RE: **Bid No. 2018-002 Lift Station No. 21 Renovation – Change Order**

CHANGE ORDER

PROJECT: CITY OF MARGATE
LIFT STATION NO. 21 RENOVATION
CAS PROJECT NO. 08-1477C21

CONTRACT FOR: LIFT STATION NO. 21, NEW WETWELL REVISION

LIFT STATION NO. 21
RENOVATION
PROFILE VIEW

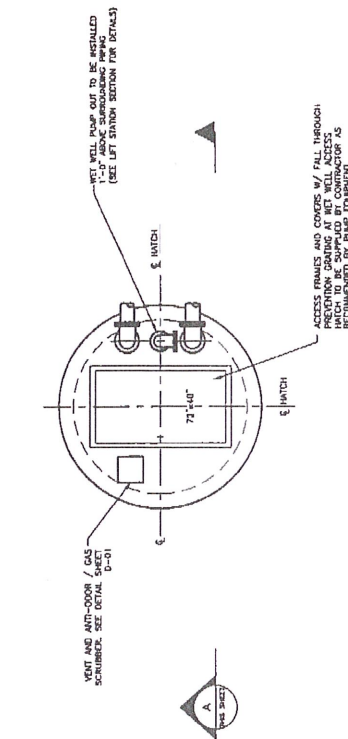
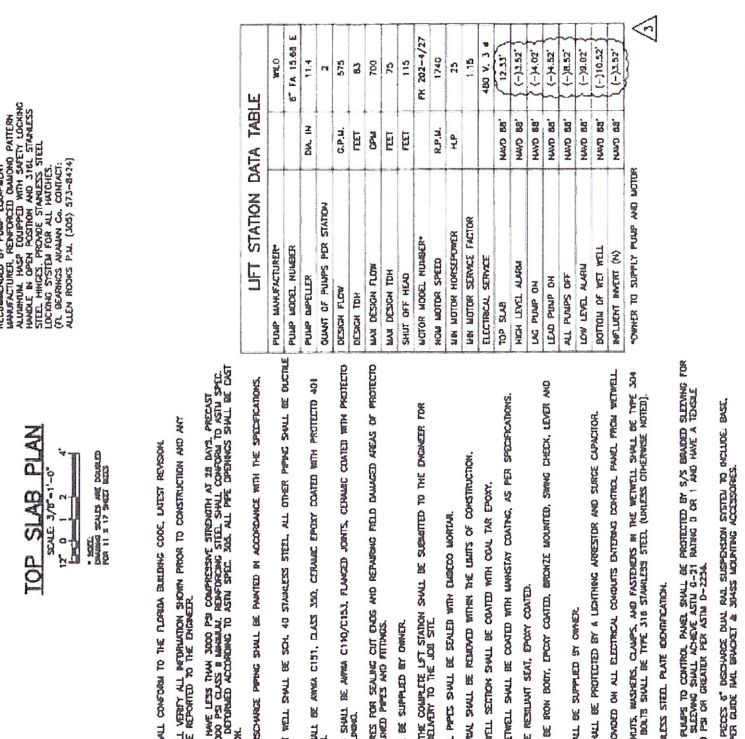
During construction, the existing wet well structure was uncovered and it was discovered that the existing structure is 6-ft in diameter; not 8-ft as shown in the bid documents. The 2-ft difference in the diameter changes the storage capacity of the wetwell and thus does not meet the specifications required for the retro-fit. After exploring several options to remedy the situation, it was determined that a new wetwell structure must be installed in order to meet the flow demands of that lift station; the new wetwell must be 22.85-ft deep and have a diameter of 8-ft.

DESCRIPTION: The addition of a new 22.85-ft deep wetwell to the project due to field conditions of the existing wetpit. This Change Order includes additional forcemain piping, influent gravity main, modifications of the existing wetpit into a terminal manhole, water service extension and additional demolition to the existing drypit. The addition of 212 days shall be added to the contract time to perform this additional work and make-up for time lost during the negotiations of this change order. The new completion date shall be set to August 31, 2019.

The design plans have been revised to reflect the required changes to the project in order to meet the flow demands (attached). The change order submitted by Southeastern Engineering Contractors, Inc. (attached) includes all work required to comply with these revisions. Included in this change order is the cost for the installation of the new 8-ft diameter wet well, additional force main piping, influent gravity main, modifications of the existing wet pit into a terminal manhole, water service extension and additional demolition to the existing dry pit.
